ADDENDUM

ADDENDUM NO: 1

PROJECT: BCSC Central Middle School Interior Renovation

PROJECT NO: 2024027

1 MEDIA CENTER - EQUIPMENT PLAN
A901 SCALE: 1/8" = 1'-0"

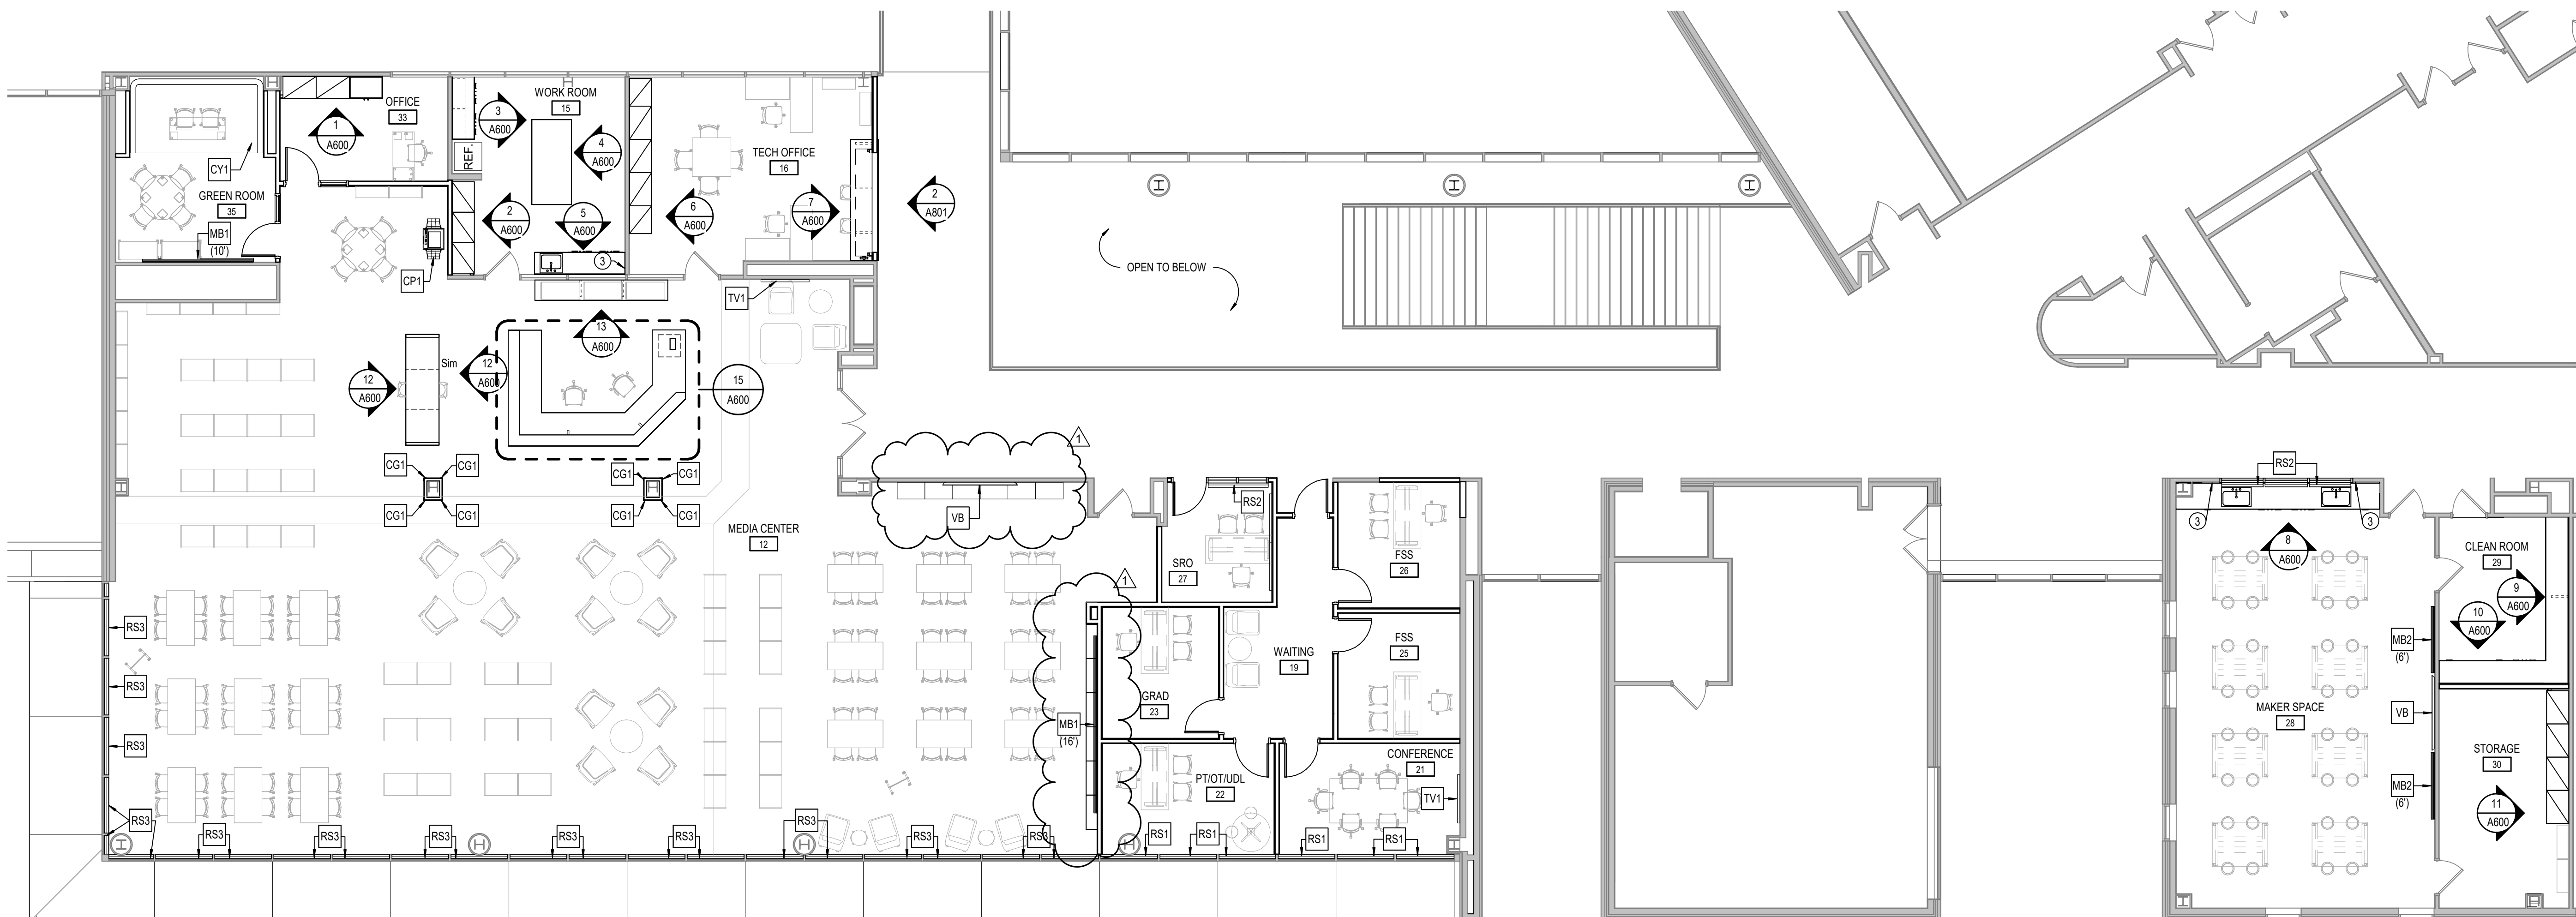
3.04 A901 – EQUIPMENT SCHEDULE, PLAN & ELEVATIONS

- A. Add REMARKS section at RS3 to say “BY ALTERNATE”.
- B. 1/A901: Switch locations of “VB” and “MB1” on plan as shown.

MEDIA CENTER FLOOR PLAN - POWER AND SIGNAL
 SCALE: 1/8" = 1'-0"
 NORTH

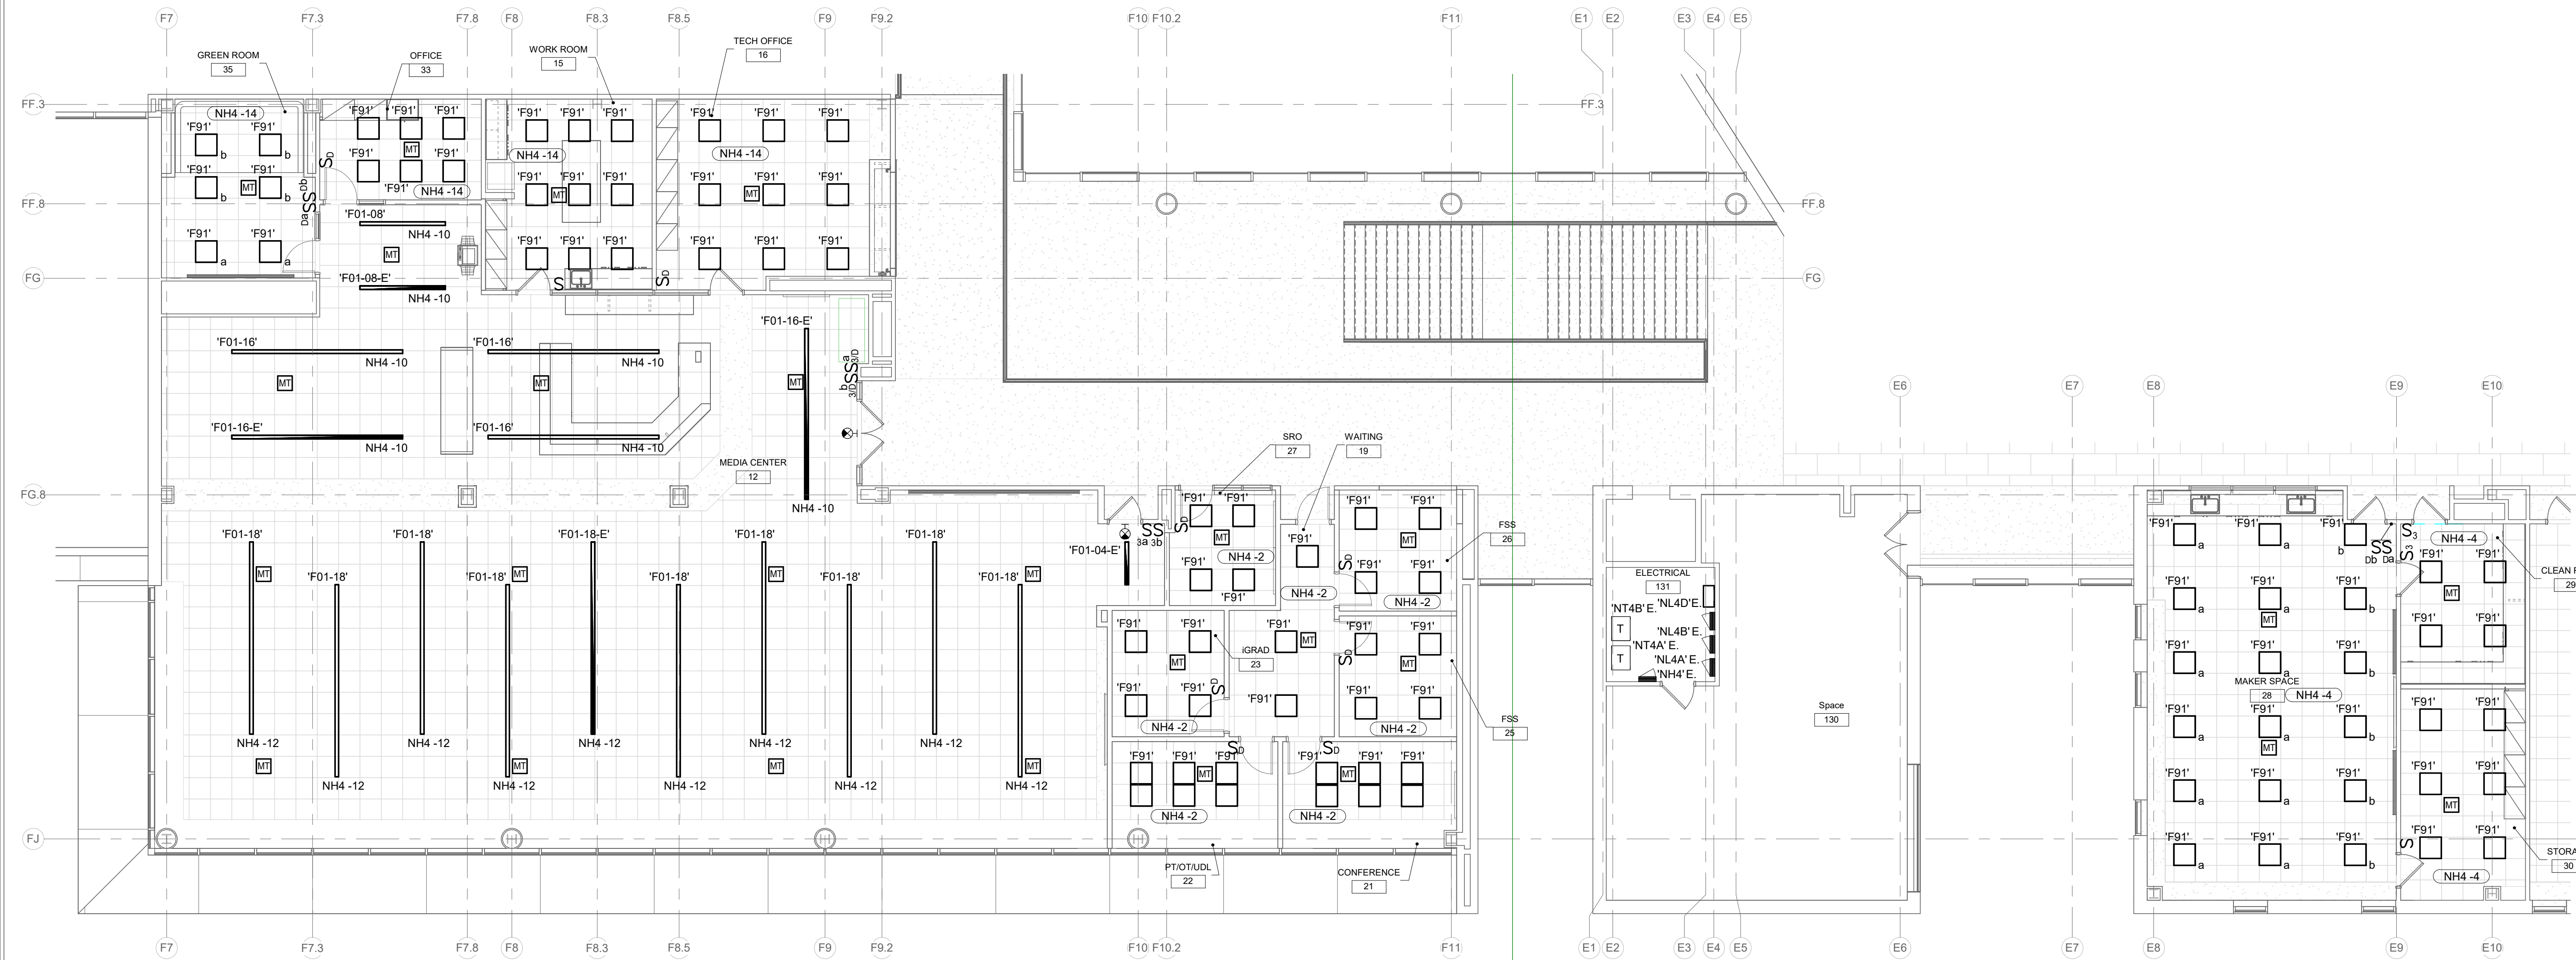
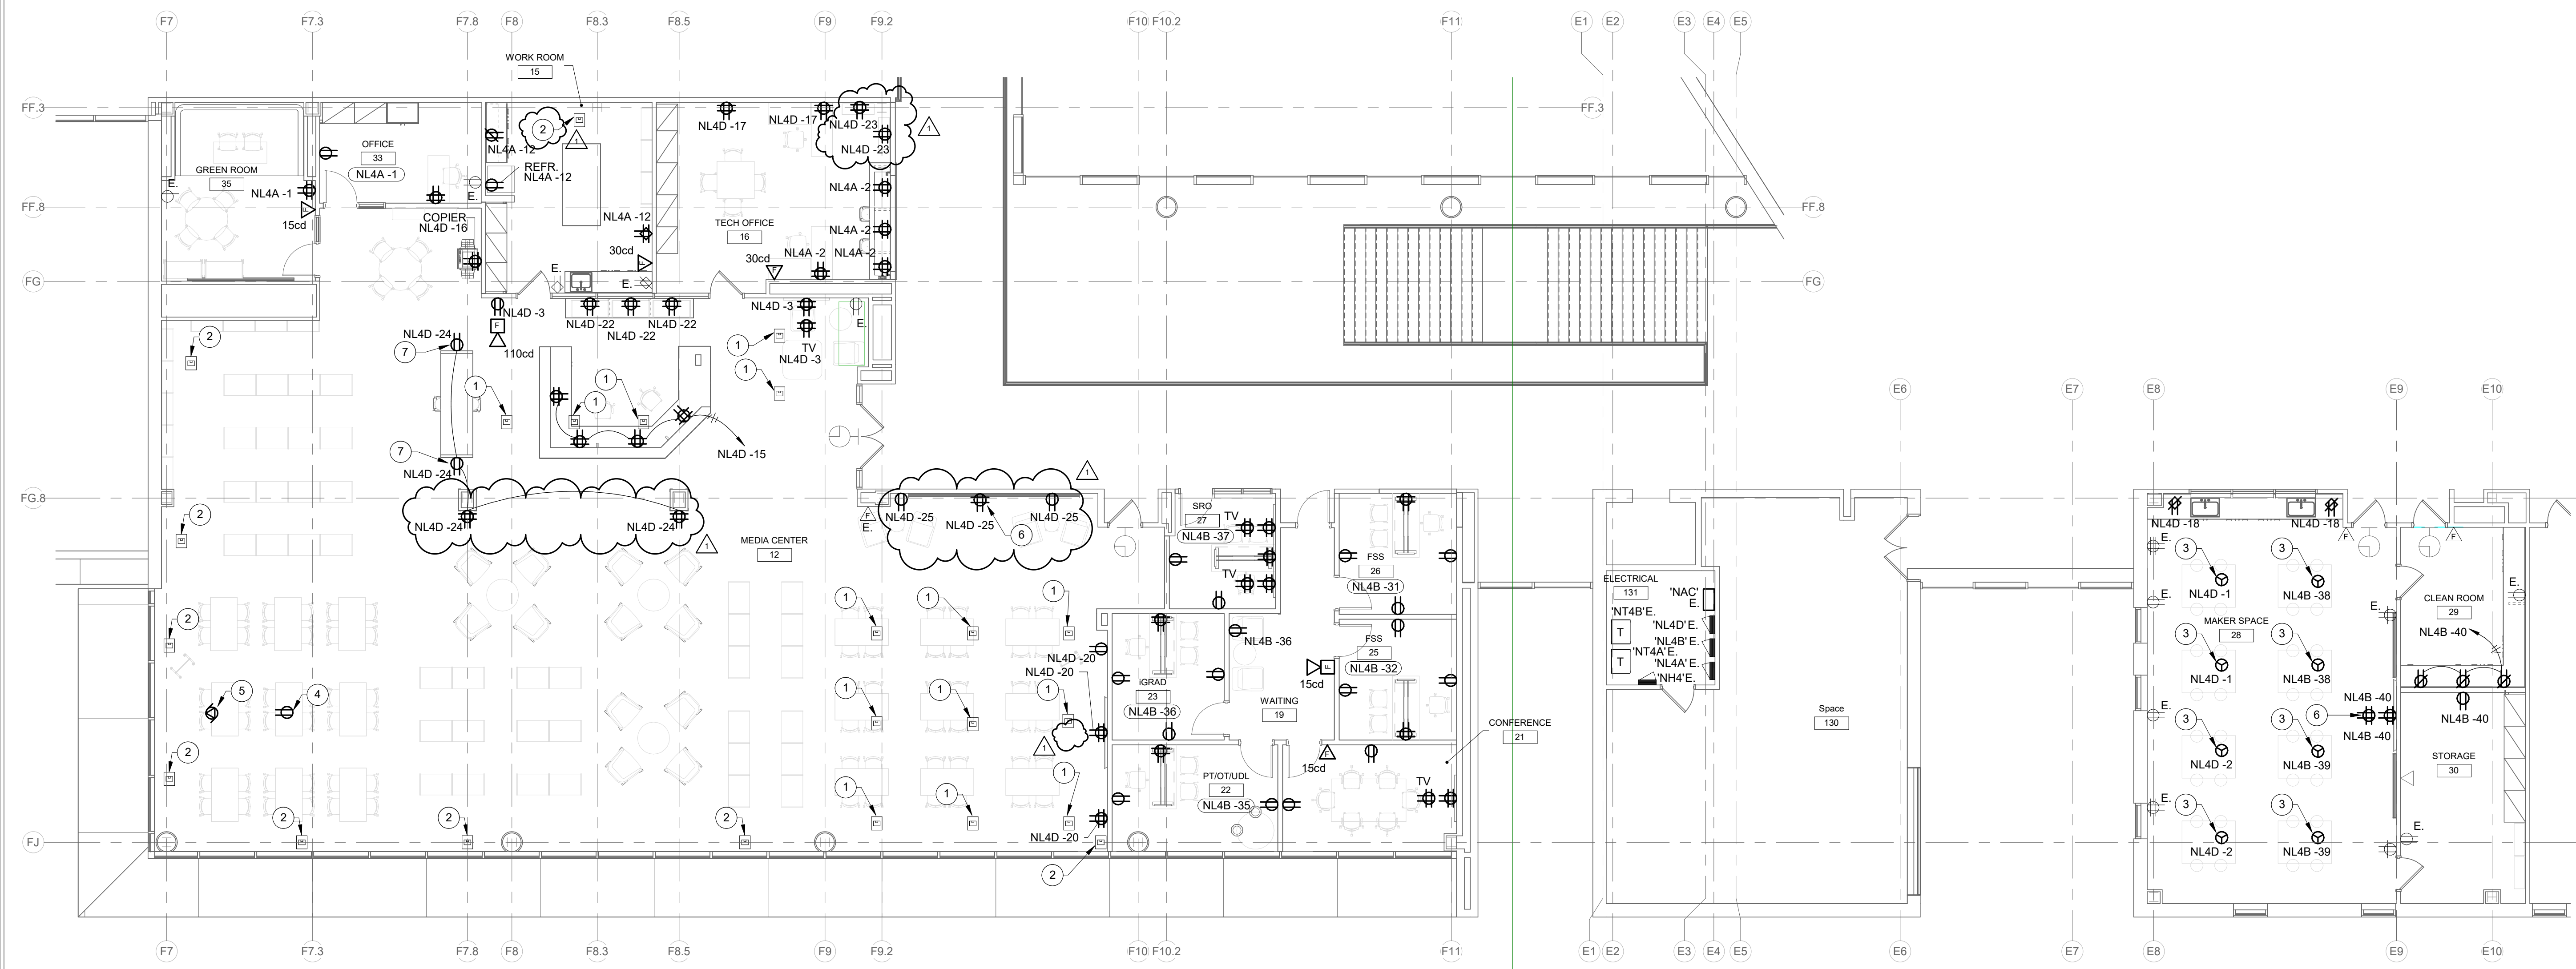
3.05 E201 – MEDIA CENTER FLOOR PLAN – ELECTRICAL

- A. Revise POWER AND SIGNAL plan as indicated on attached revised sheet.

5.03 On Drawing E201 – in the Power & Signal section, there is a note listed as **12** in the “Work Room #15.” Can you please verify if this note is supposed to be 1, 2, or a completely new note?

A. This has been addressed on attached revised sheet E201.

MEDIA CENTER FLOOR PLAN - TELECOMMUNICATIONS
SCALE: 1/8" = 1'-0"
NORTH

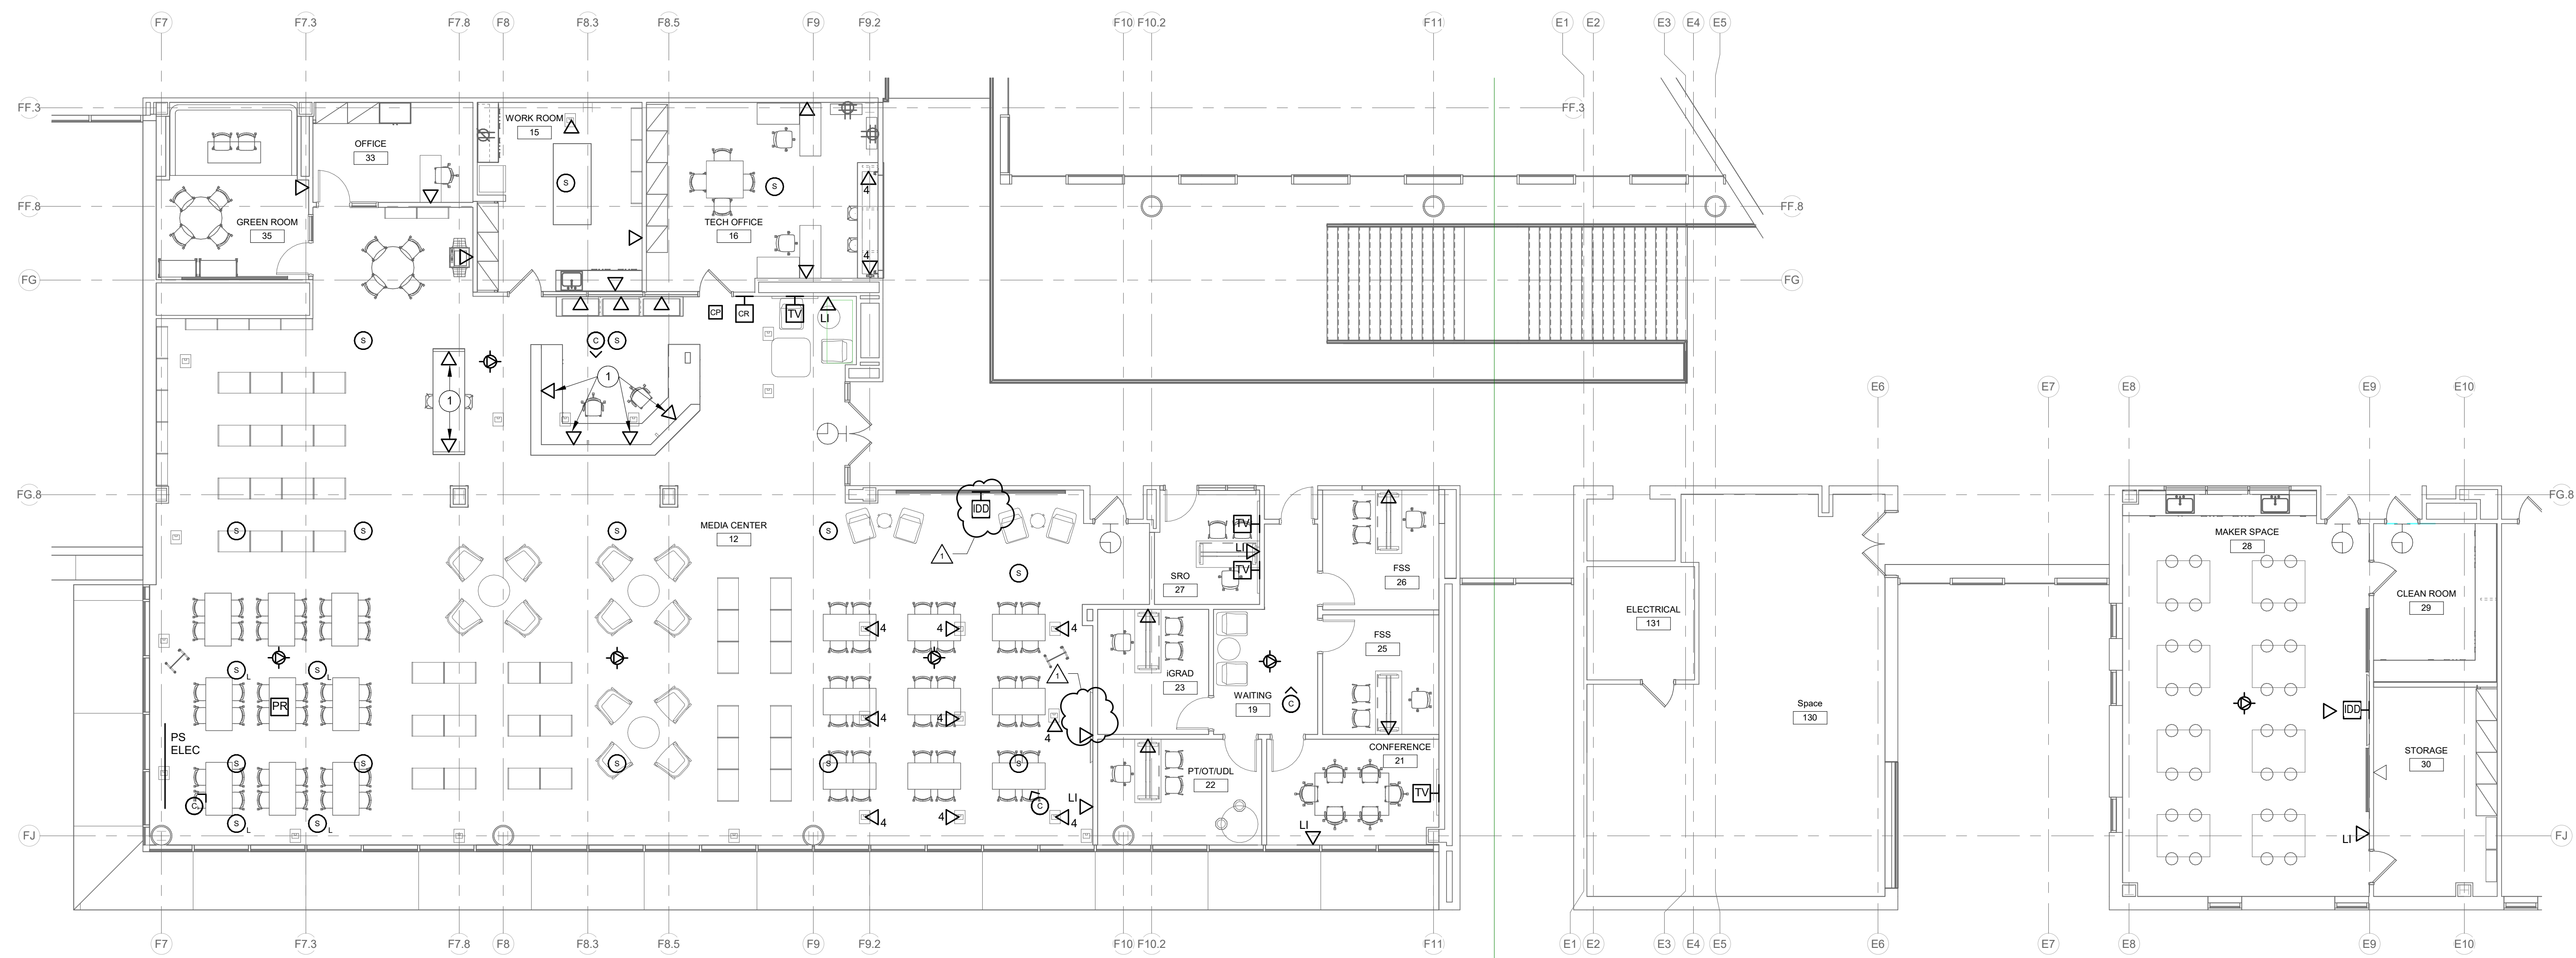
3.06 T201 – MEDIA CENTER FLOOR PLAN – TELECOM

- A. Revise TELECOMMUNICATIONS plan as indicated on attached revised sheet.
